Raleigh Historic Development Commission – Certificate of Appropriateness (COA) Application

814 Oberlin Rd Relocation + Addition

APPLICATION FOR A CERTIFICATE OF APPROPRIATENESS – STAFF REPORT

124-17-CA 814 OBERLIN ROAD

814 Oberlin Rd - New Plan

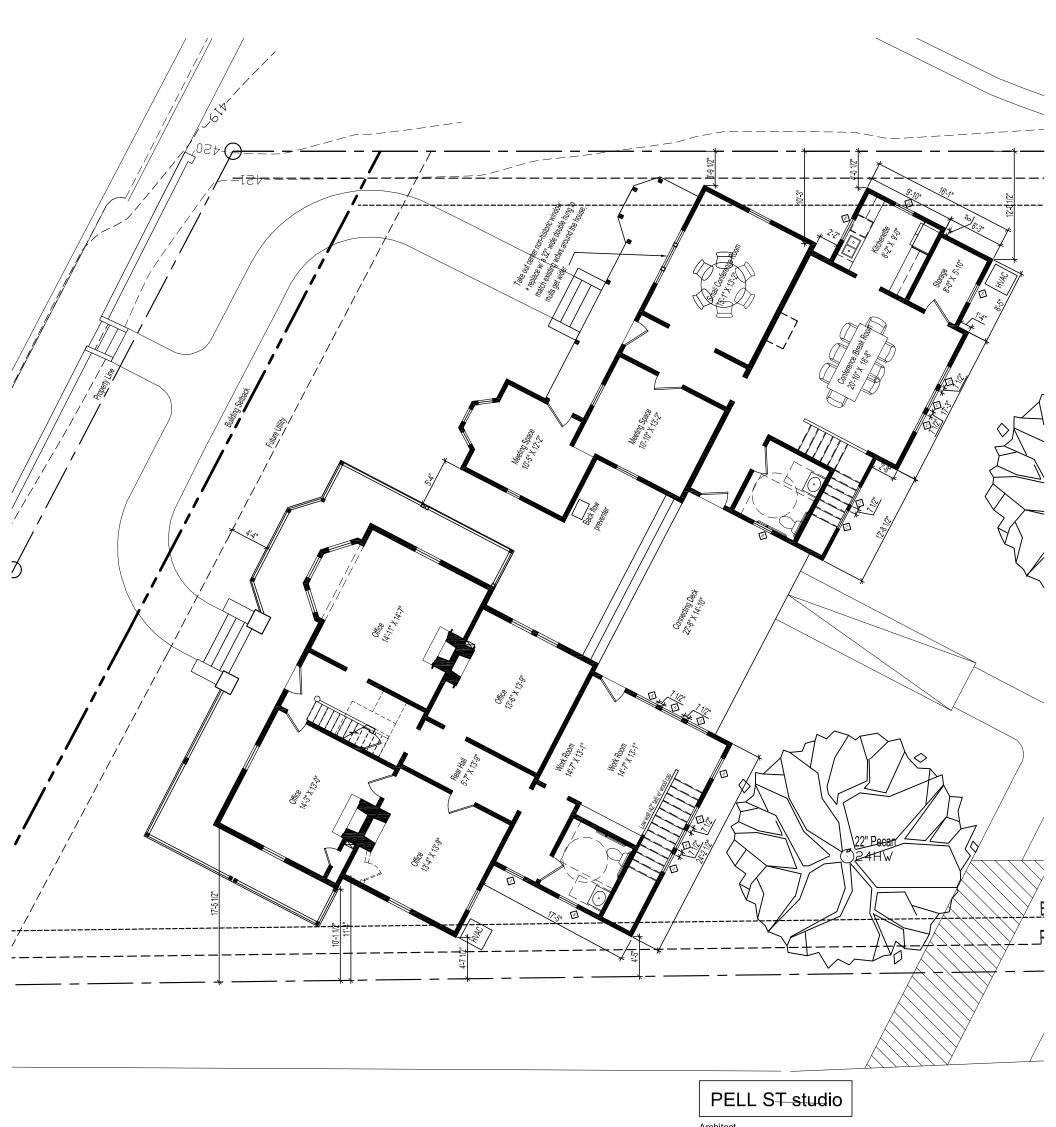
- 1* The Hall house was approved for relocation in 2016 under COA 076-16-CA. The approved site plan is included in the application, but not labeled. This proposal changes the location of the house on its current lot in order to also accommodate the relocation of the Graves house on the lot.

- 3* The 1996 addition is proposed to be removed prior to the move.
- 4* The house sits in the right-of-way. The proposed location reduces the impact to the dwelling from the existing roadway and from any future widening.

- 3. That details and specifications for the following be provided to and approved by staff prior to the issuance of the blue placard for the move:
 - a. Grading plan;
 - b. Final foundation height;
 - c. Revised foundation design under the historic house that is detailed to convey the appearance of the original pier locations.
 - d. Move route;
 - e. Tree removal;
 - f. Tree protection plan prepared by a registered landscape architect or ISA-certified arborist.
- 4. That details and specifications for the following be provided to and approved by staff prior to the issuance of the blue placard for the addition:
 - a. Revised elevation drawings showing windows on the addition using the proportions of one of the existing windows;
 - b. New front window;
 - c. Front porch flooring;
 - d. Eave construction;
 - e. Window and door trim.

Preliminary Tree Removal List

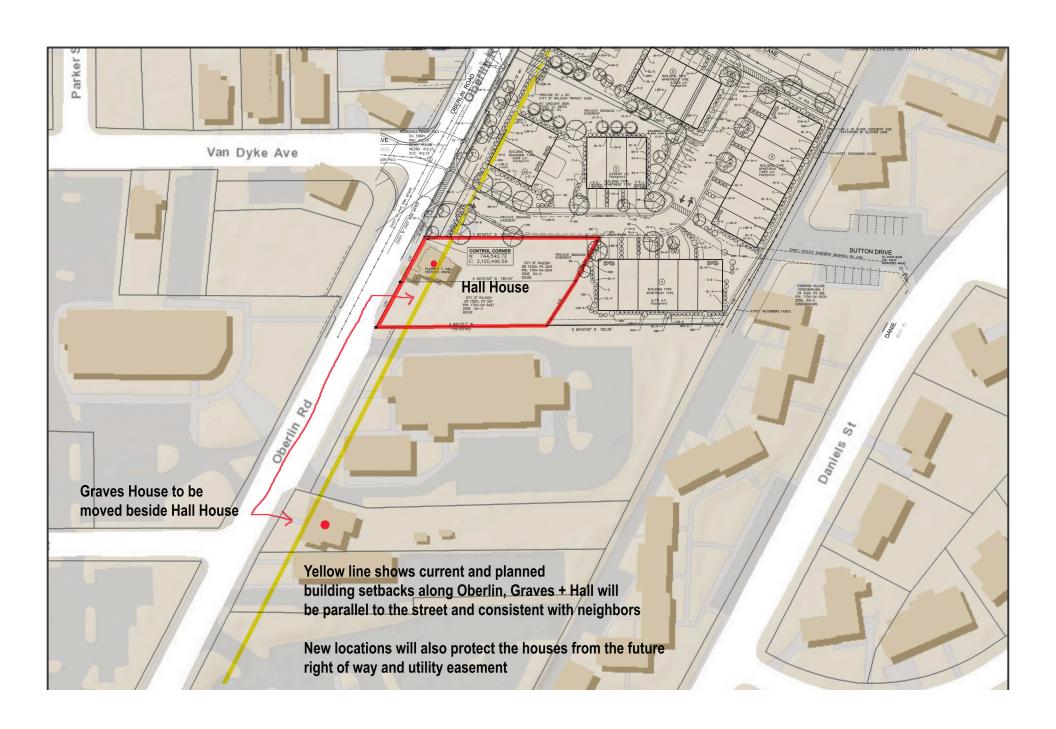
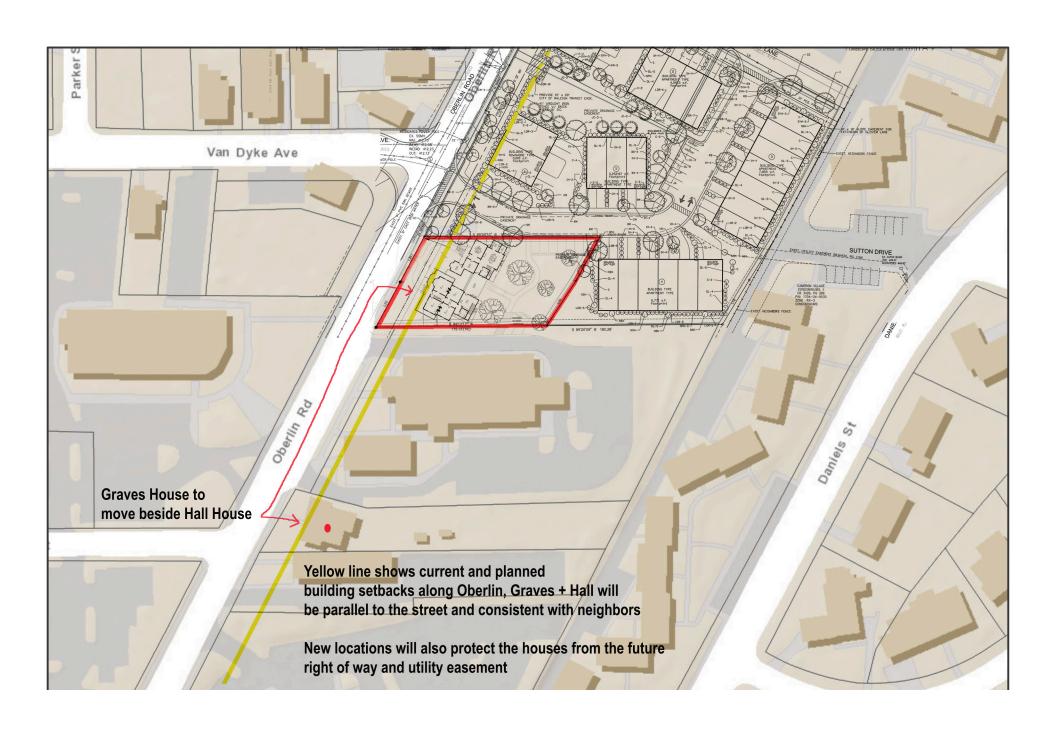
- 2* A tentative tree protection plan is provided; it was not prepared by a certified arborist or registered landscape architect. A preliminary tree removal plan has been provided; the exact move route has not been determined. See item H for tree removals.

- 1* A preliminary list of trees to remove was provided. Only trees affected by the relocation of the houses, located within utility easements, or located in the proposed parking area are

- 2* Five mature trees and several smaller trees will remain.
- 3* A tree replacement plan was not provided.

- 9. That the approved tree protection plan (per conditions 3.f. and 6.f.) be implemented prior to any work on the site and that it remain in place for the duration of construction.
- 10. That details and specifications for the following be provided to and approved by staff prior to the issuance of the blue placard for the moves:
 - a. Tree replacement plan.
- 11. That replacement trees be planted during the next tree planting season after receipt of the certificate of occupancy.
- 12. That details and specifications for the following be provided to and approved by staff prior to construction or installation:
 - a. Deck;
 - b. Ramp;
 - c. Parking area materials;
 - d. Walkway materials;
 - e. Site lighting.
 - f. Any other site changes required for the project not specifically addressed.
